SUBJECT: Forwards responses to draft SER open items re in-core exit thermocouple & subcooling instrumentation sys (NUREG-0737, Item II.F.2) & release of particulates & iodines from condenser vacuum pump exhaust.

SHEARON HARRIS NUCLEAR POWER PLANT  
UNIT NOS. 1 AND 2  
DOCKET NOS. 50-400 AND 50-401  
DRAFT SAFETY EVALUATION REPORT RESPONSES

Shearon Harris Nuclear Power Plant  
Draft SER Open Item 31  
Supplemental Information

Shearon Harris Nuclear Power Plant  
Draft SER Open Item  
Additional Information

Figure 1

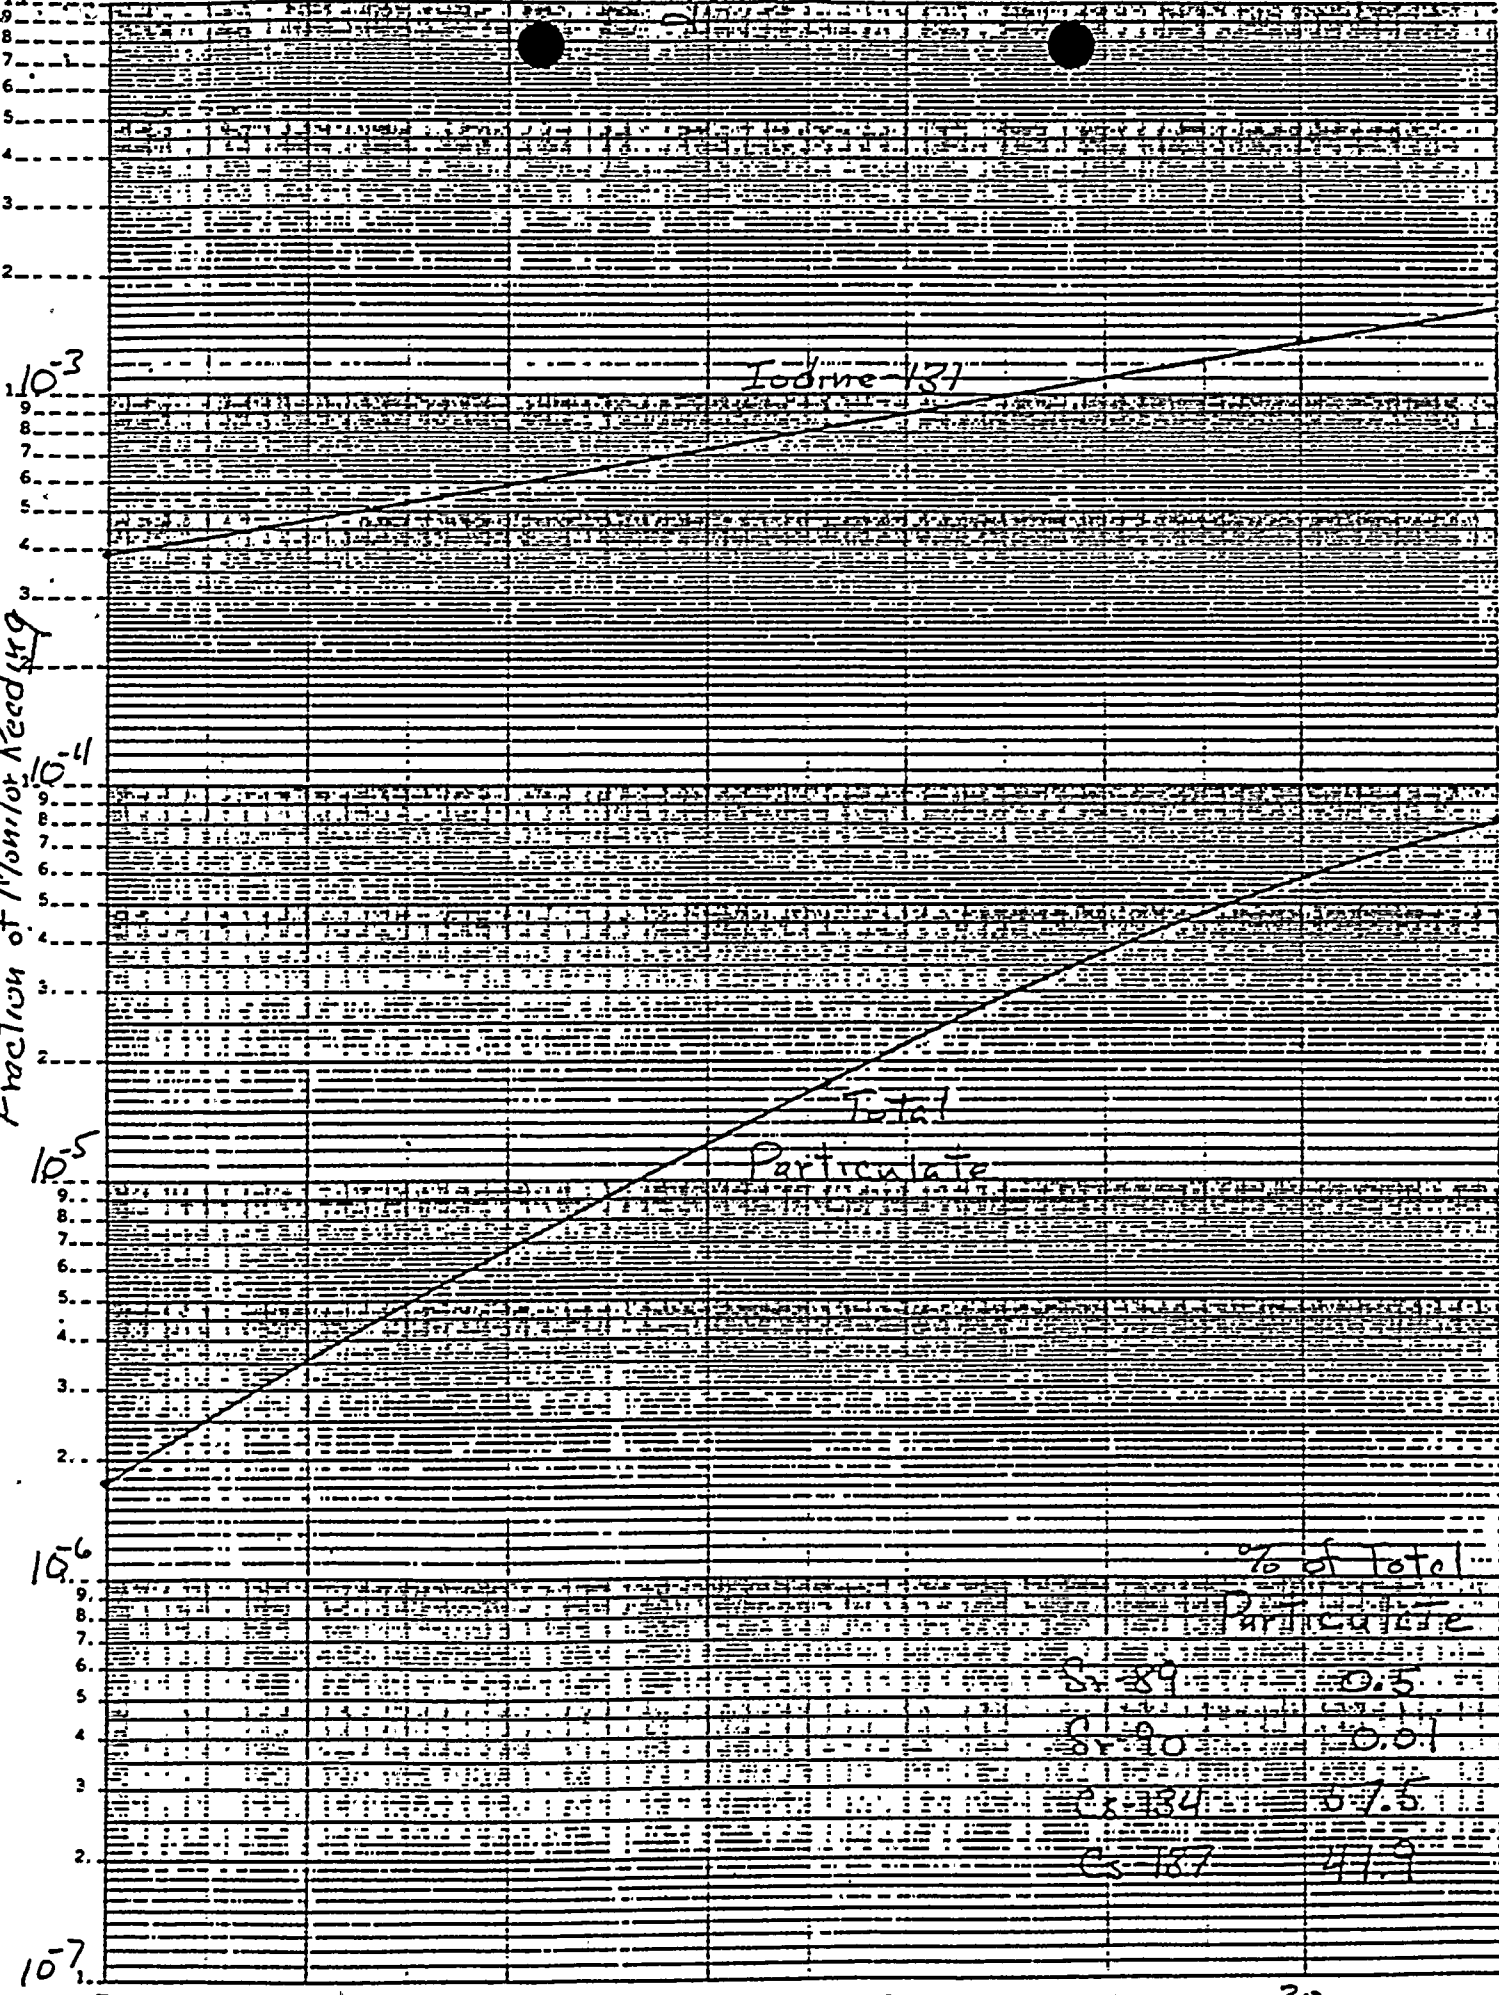
Provide additional information on the release of particulates and iodines from the condenser vacuum pump exhaust.

1. Identify the amount of time passed since shutdown.
2. From Figure 1 of Attachment 1 pick the appropriate composition function values for particulates and iodines.

6. Having calculated the Xe-133 concentration multiply it by the composition fractions obtained via Step 2 above. (In the case of a short shutdown less than 40 days it can be assumed that the sole contributor to monitor readings is Xe-133, the effect of Kr-85 can be ignored.)
